# Access Compliance Report

## Public Rights-of-Way

Intersection ID: 48410	Main Street: CAIRNS_MILL_CT	Cross Street: BELMAR_PLACE_RD	Location: SE
ADA ID: EBF63EB95D2D	Ramp Type: Perp	Initial Pass/Fail: Fail	Overall Compliance: No
Codes/Mitigation Info/Possible Solution		Field Measurements/Component Compliance	
Severity Score: 13.75

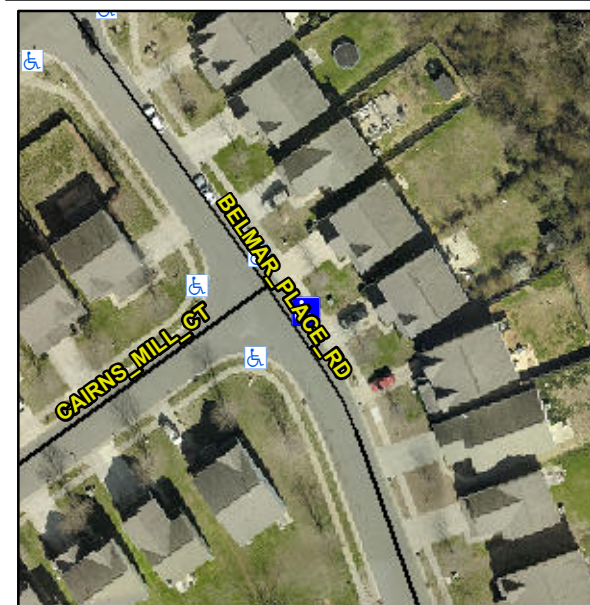
**Not Found, R304.2.2**

Compliance	Description	Data	Compliance	Description	Data
N/A	Ramp Length (in)	48.0	No	Ramp Slope (%)	8.4
Yes	Ramp Width (in)	48.0	Yes	Ramp XSlope (%)	3.0
N/A	Flare Type LT	N/A	N/A	Flare Type RT	N/A
N/A	Flare Slope LT (%)	N/A	N/A	Flare Slope RT (%)	N/A
N/A	Flare Traversable LT?	N/A	N/A	Flare Traversable RT?	N/A
N/A	Landing Length (in)	N/A	N/A	DWS Provided?	N/A
N/A	Landing Width (in)	N/A	N/A	DWS Contrast?	N/A
N/A	Landing Slope (%)	N/A	N/A	DWS Length (in)	N/A
N/A	Landing X Slope (%)	N/A	N/A	DWS Full Width?	N/A
N/A	Landing Curb? (Y/N)	N/A	N/A	DWS Offset (in)	N/A
N/A	Shared Landing?	N/A			
N/A	Gutter Ponding?	N/A	N/A	Gutter Slope (%)	N/A
N/A	Gutter Lip Ht (in)	N/A	N/A	Gutter X Slope (%)	N/A
N/A	Painted X Walk1?	No	N/A	Painted X Walk2?	N/A
	X Walk 1 Direction	To W		X Walk 2 Direction	N/A
N/A	X Walk 1 Width (in)	N/A	N/A	X Walk 2 Width (in)	N/A
	X Walk 1 Slope (%)	0.9		X Walk 2 Slope (%)	N/A
	X Walk 1 X Slope (%)	3.0		X Walk 2 X Slope (%)	N/A

**Remove & Replace Entire Ramp.**
